## SERVICE BULLETIN

**NUMBER:** 16-156-25R  
**DATE:** 09/15/25  
**REVISED:** 10/28/25

**SUBJECT:** CVT Control Valve Body Design Change / P2757, P2762, & P06EF

#### Step 4: Data Recording and Lock-Up Duty Ratio Analysis

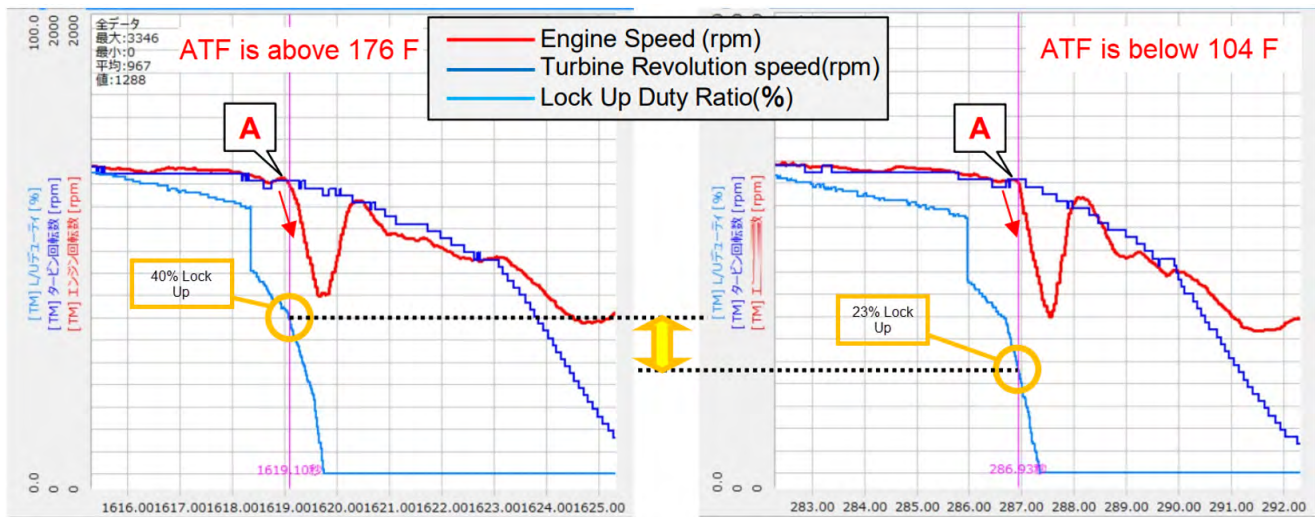
Perform a test drive while recording data using the Subaru Select Monitor, ensuring that all TCM data PIDs are captured. During the test, decelerate the vehicle from 25 mph to a complete stop twice when the CVT fluid temperature is below 104°F, and then twice more when the temperature is above 176°F. Graph the recorded data, set torque converter speed and engine speed range of 0 to 3000 rpm. Analyze the deceleration events where engine speed and torque converter speed no longer overlap on the graph (see example graphs below). At these points, determine whether there is a 10% or greater difference in the Lock-Up Duty Ratio (%) between the data recorded at 176°F and 104°F, specifically when the torque converter clutch is released.

NOTE: 'A' indicates a point where a difference occurs between the engine speed and the turbine revolution speed, marking the moment when the lock-up clutch is disengaged.

Example:  $40\% - 23\% = 17\%$

Note: To determine the difference of Lock-Up duty Ratio Subtract the Lock-Up Duty Ratio when ATF temperature is below 104°F from the Lock-Up Duty Ratio when ATF temperature is above 176°F.

**Yes** – Replace the valve body and go to Step 5.

**No** – Go to Step 5.

## Step 5: Data Recording and Lock-Up Duty Ratio Analysis

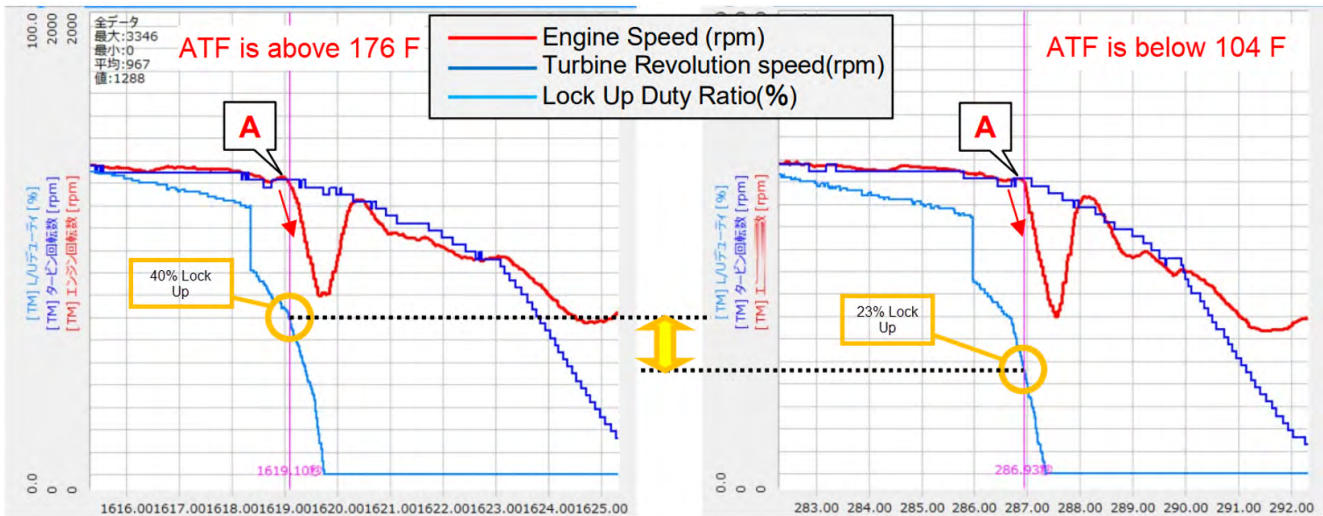
Perform a test drive while recording data using the Subaru Select Monitor, ensuring that all TCM data PIDs are captured. During the test, decelerate the vehicle from 25 mph to a complete stop twice when the CVT fluid temperature is below 104°F, and then twice more when the temperature is above 176°F. Graph the recorded data, set torque converter speed and engine speed range of 0 to 3000 rpm. Analyze the deceleration events where engine speed and torque converter speed no longer overlap on the graph (see example graphs below). At these points, determine whether there is a 10% or greater difference in the Lock-Up Duty Ratio (%) between the data recorded at 176°F and 104°F, specifically when the torque converter clutch is released.

NOTE: 'A' indicates a point where a difference occurs between the engine speed and the turbine revolution speed, marking the moment when the lock-up clutch is disengaged.

Example: 40%-23%=17%

Note: To determine the difference of Lock-Up duty Ratio Subtract the Lock-Up Duty Ratio when ATF temperature is below 104°F from the Lock-Up Duty Ratio when ATF temperature is above 176°F.

**Yes** – Replace the valve body and go to step 7.

**No** – Go to Step 6.
